Combined Permit Set 12/13/2021

Admiralty Apartments
Repairs & Improvements

Phase I

8

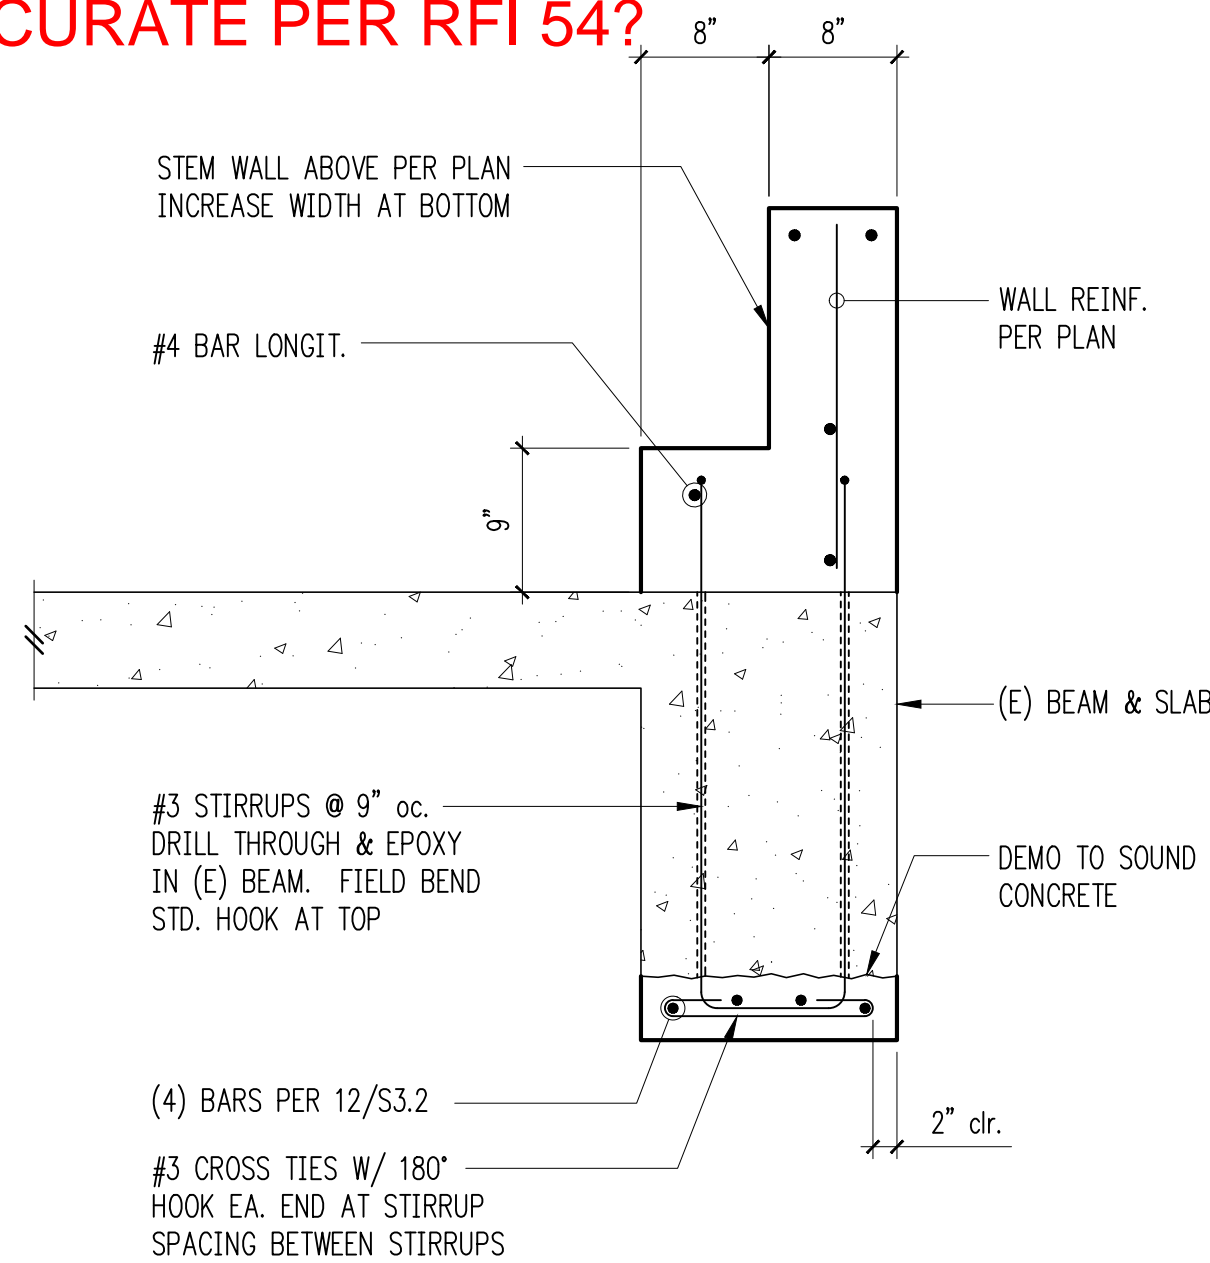
IS THIS STILL ACCURATE PER RFI 54?

S4.2

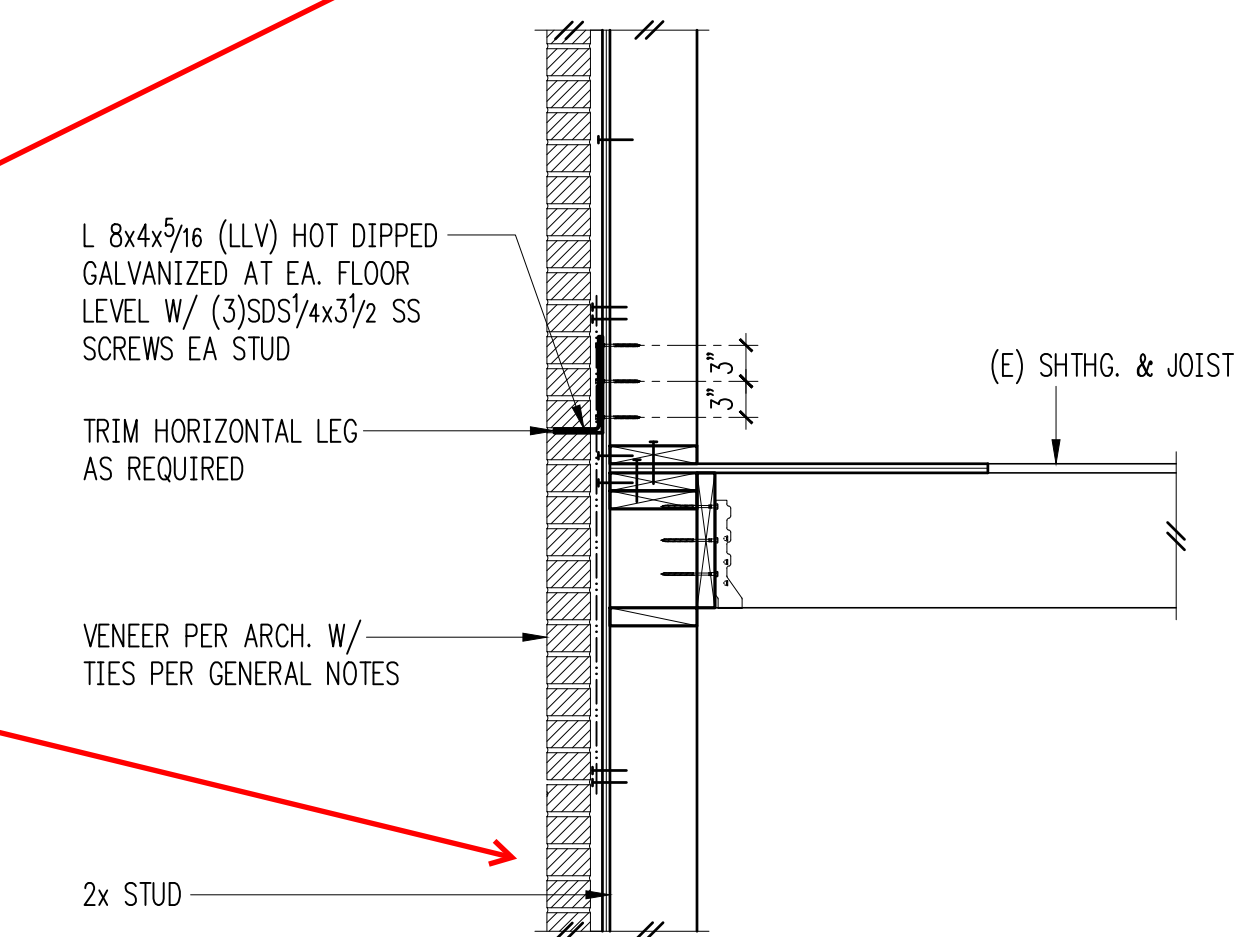
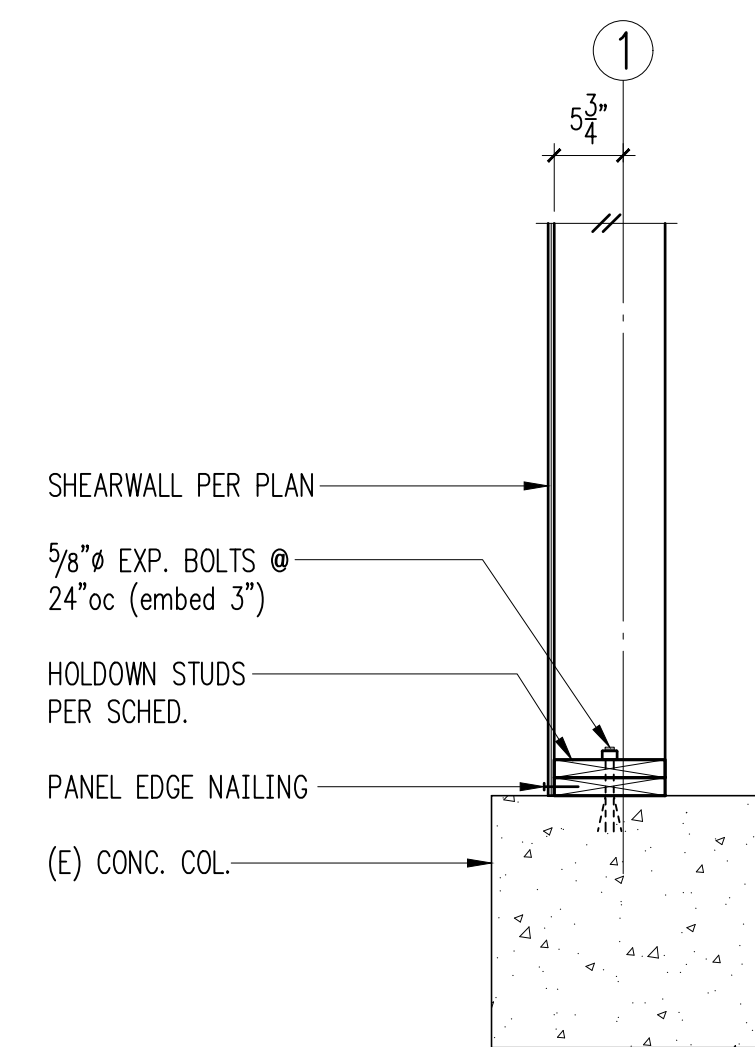
**HAVE THESE CHANGED PER RFI 54?
SHOULD THERE BE ONE NEW DETAIL AND POINT
TO THAT?**
